SERVICE BULLETIN

APPLICABILITY: 2010-2013 Legacy and Outback Models
SUBJECT: Sunroof Does Not Open or Close Properly
 Popping or Slamming Sound When Glass Lowers
 Prior To Opening

NUMBER: 07-72-13
DATE: 01-29-13

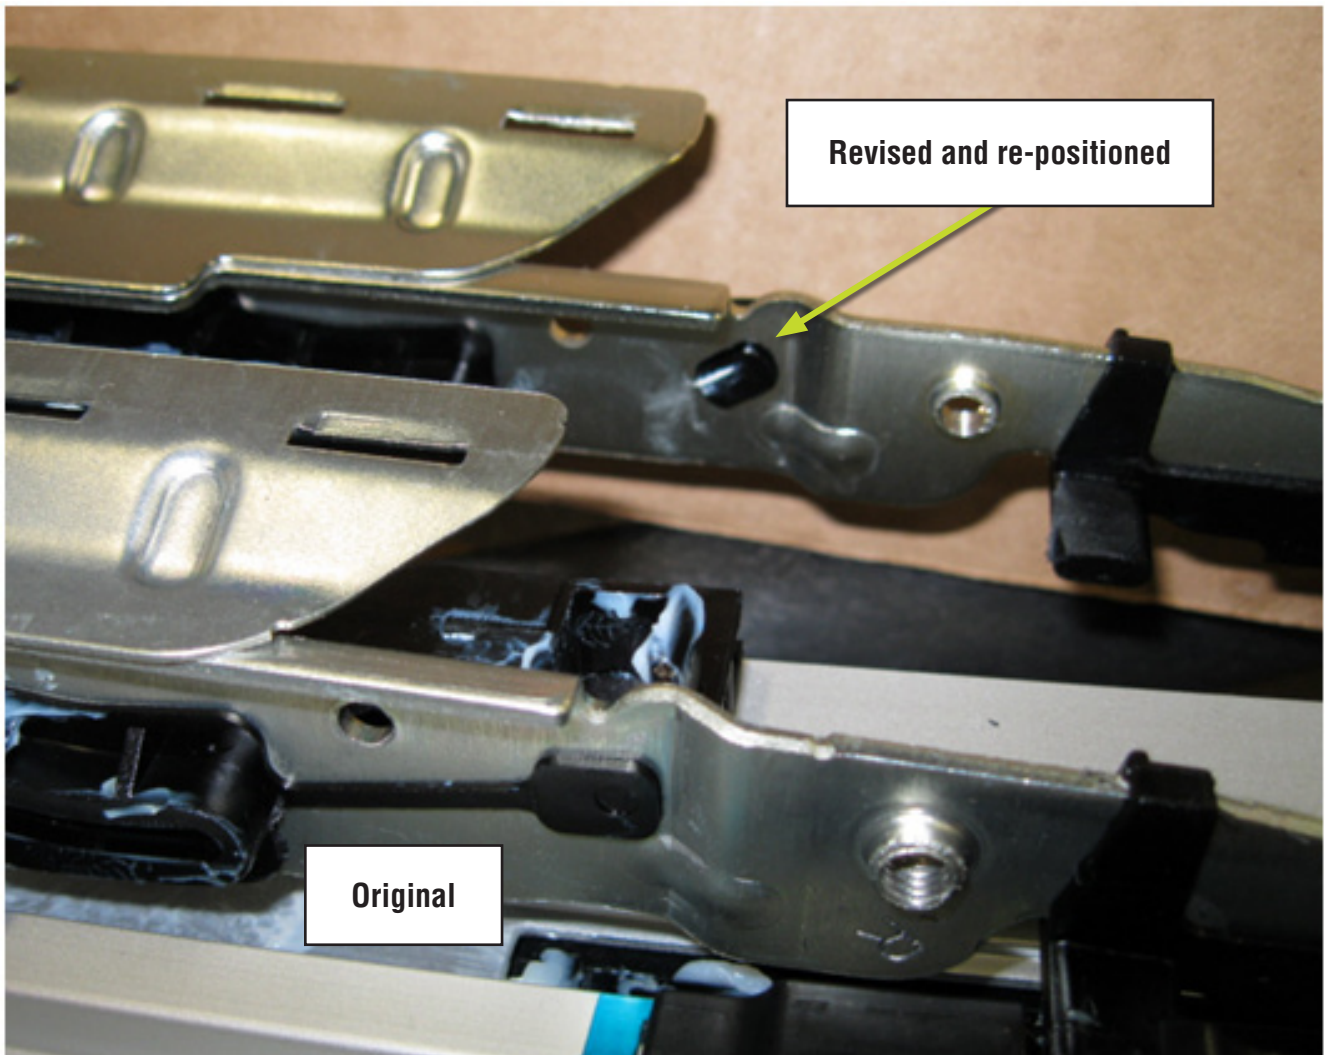
While the rail (sunroof frame) assembly remains virtually unchanged, significant revisions have been made to the cable assemblies (lid brackets) to increase their durability, rigidity and ease of operation as shown in the photos below.

The “Cable Repair Kit” consists of a revised lid bracket and sunroof operating cable assembly.

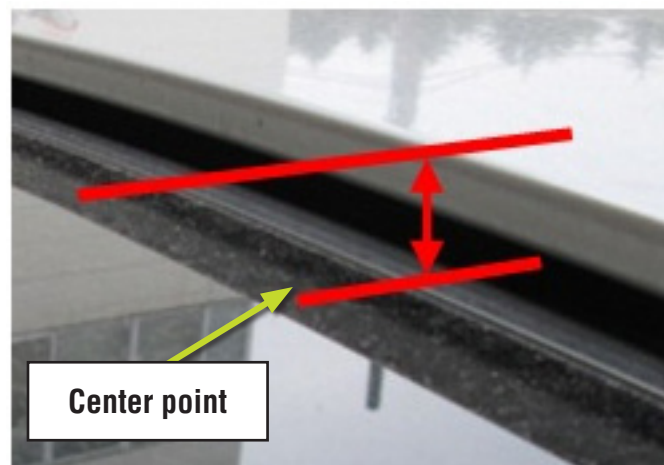
- Open the sunroof to the point where the rear edge of the glass is fully dropped down, just before it retracts under the roof panel.
 - o Determine the center point of the back edge of the glass panel by measuring from the outside edges in toward the middle from each side.
 - o Measure the distance between the top outside edge of the roof opening flange and the glass panel as shown in the photo below.

The standard values are 21.7 mm for Legacy, and 21.9 mm for Outback.

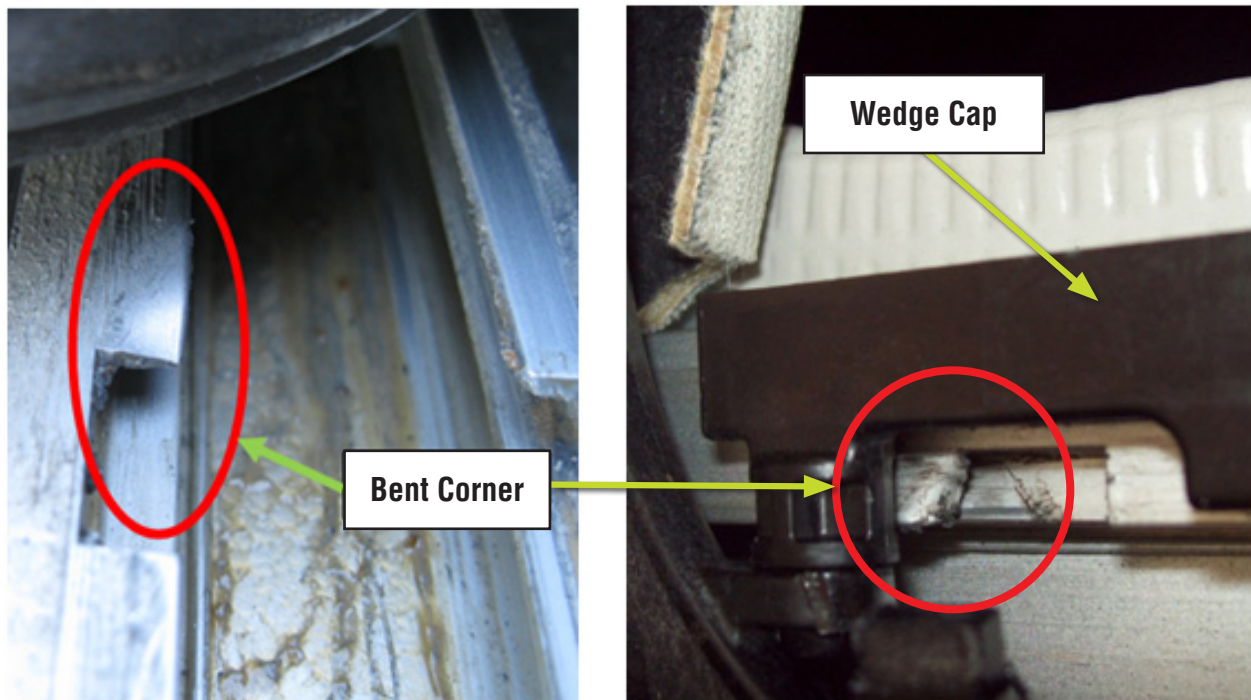
If the measurement is correct, inspect the gap from side to side and make sure it is even (one side is not higher or lower than the other). The photo below shows an Outback sunroof with the left (driver's) side of the glass panel much higher (narrow gap) than the right.

In this case, although the sunroof on this vehicle is operational, the corners of the rectangular openings in the side rails have become deformed (bent) as shown in the photos below. This keeps the lid bracket shoe from dropping into the rectangular opening in the side rail as it should. Instead, when the glass panel retracts, the lid bracket shoe rides on top of the side rail instead of inside the channel causing the condition shown in the photo above. Again, if any deformation of the rail or the wedge cap is confirmed, replacement of the rail assembly along with both cable assemblies is required.
